Date: 29 November 2021

Checklist Comments Report – Response

Project Name: 411 Michigan Ave

HPB Plan Version 2 Corrections Report Response (HPB21-0486)

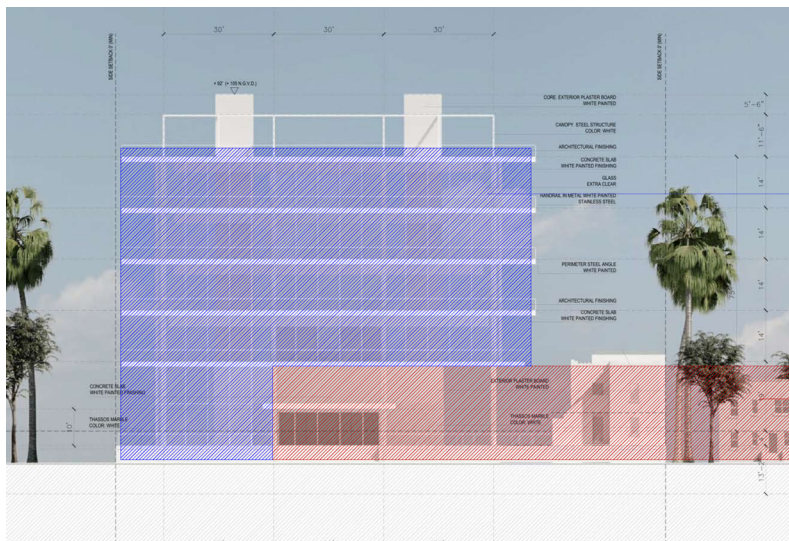
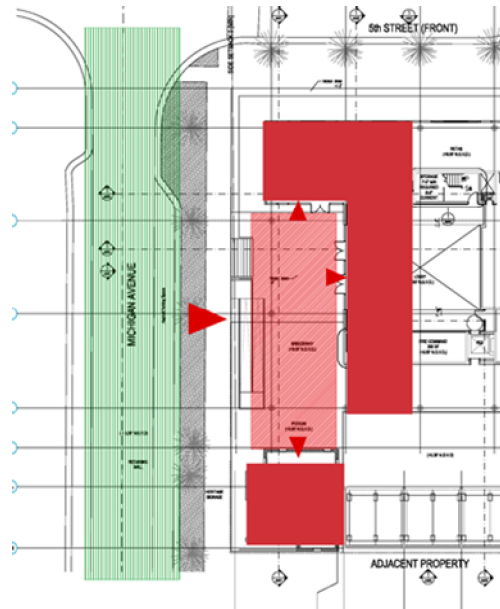
- c. *Provide in narrative and/or visual form, the design inspiration for the designs of the buildings including how they relate to the fabric and architectural heritage the surrounding historic district and greater Miami Beach.*

411 Michigan is a "gateway" building on 5th Street, one of the most prominent vehicular arteries in Miami Beach. 411 Michigan is also placed in a significant historic neighborhood where several key architectural styles from different times converge. In recognizing this unique opportunity, we responded to the site's recognizable position and historical ties by commissioning a master contemporary Architect who's designs profoundly recognize both the past and the future. We established the following principles that each respond to a particular architectural tradition in South Miami Beach: symmetry (Art Deco), activated outdoor space (Mediterranean Revival), and minimalism (MiMo). These principles become the foundation and genesis of our design for 411

Symmetry is an essential characteristic to the Art Deco style. The plan, elevation and sectional diagram of the building are all cleanly and identifiably symmetrical.

Mediterranean Revival features “courtyard[s] and arcades, loggias and porches to provide easy access to the outdoors”. Mediterranean Revival is reflected in this building through the open to the sky courtyard at the 3rd Level, the Entry Plaza, and the large wrapping balconies on every floor.

MiMo’s Design Guidelines reference courtyards and open-air corridors that directly speaks to the contextual plan diagram and demands from climate and use; all of which are elements utilized in our proposal for the new office building at 411 Michigan. MiMo’s Design Guidelines also reference breeze blocks to reference Art Deco, which are the key building element of our stand alone garage behind the historic house. The design of our building coincides within the design guidelines for this neighborhood and the context of South Beach.

The plaza at the entry podium is the first area where visitors would be able to experience all programs of our site (office, retail, and historic house retail) and functions as a congregational/buffer zone from eastbound traffic approaching on 5th Street. Therefore, the north-facing historic house is more consistent with the site plan logic and aligns with the city’s goal to promote activated semi-public spaces.

The new building is designed with modest ‘transparent’ materials; the window assembly is built with butt-mullions (structure behind the glass) to appear floating. The wrap around balconies aid in making the glass-enclosed space to appear as something between indoor and outdoor; giving a lightness and airiness to the structure. It does not ‘overwhelm’ the

historic house, but rather creates a natural transition from the 'solid'/low-rise historic context, to the 'permeable'/mid-rise facing the major gateway street. The two scales are linked with a formal language of modern minimalism and a gestural consistency with the 2nd floor balcony and the roof of the historic building being co-planar.
